## **Preliminary application 1 (P1) 5/11/2012**

## **B1 - MEANS OF ESCAPE OBSERVATIONS**

PREMISES: Grenfell Tower  
APP No: Preliminary  
SUBMISSION No: Preliminary (P1)  
DRAWINGNo: MT13779R.Iss01-GrenfellTower-Fss, 1279\_RE110\_REV05,  
1279\_RE111\_REV04, 1279\_RE112\_REV04, 1279\_RE113\_REV04,  
1279\_RE114\_REV03.

GROUND FLOOR

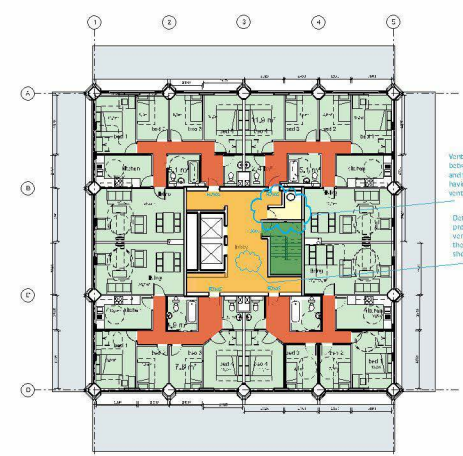
1. The new lift located within the common stair enclosure should be designed as a fire fighting lift.
2. The common lobby that forms the enclosure to the lifts should be provided with smoke ventilation. Please submit details in respect to this requirement.
3. The common stair and lobby should be designed for fire fighting purposes, in respect to the fire resistance of the enclosing walls, ventilation, doors and fire fighting facilities.
4. The open counter to the concierge office should be provided with a two hour fire resisting shutter that closes on the detection of smoke within the office. The shutter should show compliance with PAS 121, having the necessary smoke seals etc.
5. The final exit door from the common stair should be at least the width of the stair.

6. The kitchen and store rooms should be enclosed in half hour fire resisting construction having FD30 fire resisting doors.

OFFICE LEVEL

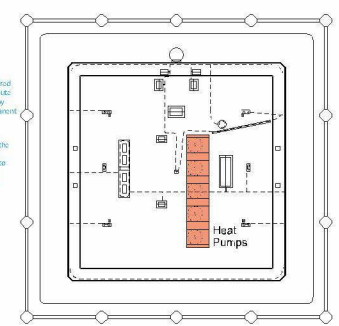
15. Items 2, 3, 8 and 10 as given above also apply at this level.

WALKWAY LEVEL

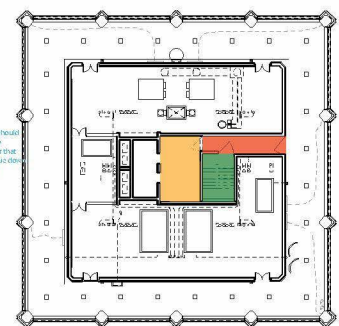
13. The common stair serving the upper floor levels should connect directly to the common stair serving the lower floor levels that leads to the final exit at ground floor level. The common stair serving the upper floors as shown on the plan seems to show the stair being accessed from the common lobby which would not be appropriate.
14. Items 2 and 3 as given above also apply at this level.
